DEVELOPMENT APPLICATION ASSESSMENT REPORT

Application Number:	DA2021/2044
----------------------------	-------------

Responsible Officer:	Gareth David
Land to be developed (Address):	Lot 141 DP 16212, 68 Rickard Road NORTH NARRABEEN NSW 2101
Proposed Development:	Alterations and additions to a dwelling house including a hardstand parking area
Zoning:	R2 Low Density Residential
Development Permissible:	Yes
Existing Use Rights:	No
Consent Authority:	Northern Beaches Council
Land and Environment Court Action:	No
Owner:	Alastair Alexander Fitzpatrick Kelly Fitzpatrick
Applicant:	Alastair Alexander Fitzpatrick

Image 1- Building envelope non-compliance along north-western elevation (highlighted in green).

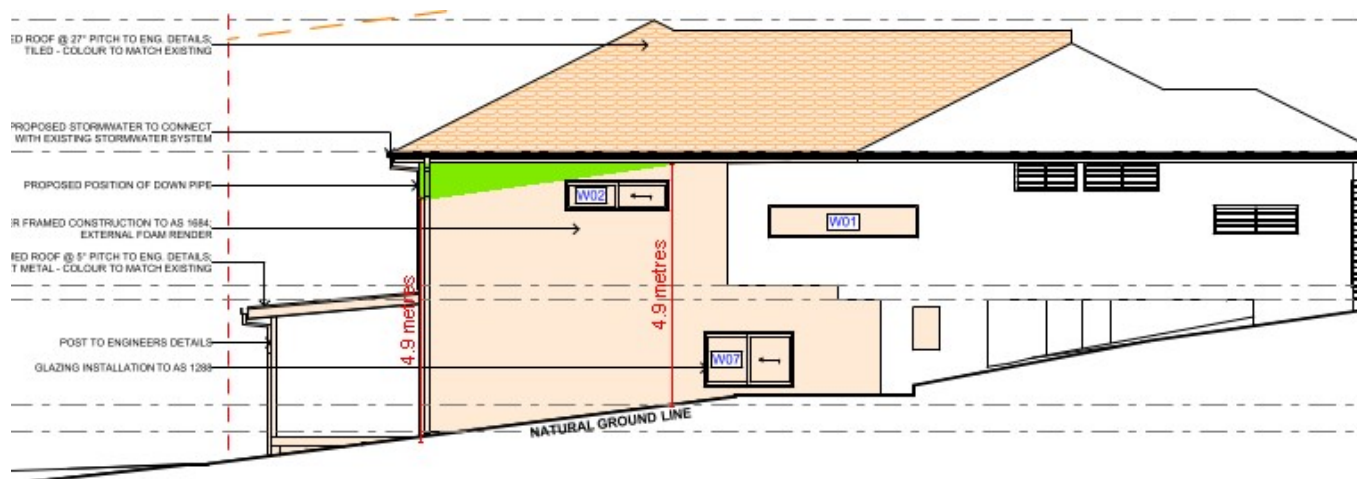
The DCP requires that the building be within a building envelope measured at 45 degrees from 3.5m above the side boundary line.

The proposal has a non-compliance to the building envelope on the north-western elevation. The extent of the building envelope non-compliance is shown in figure 1 below (highlighted in green):
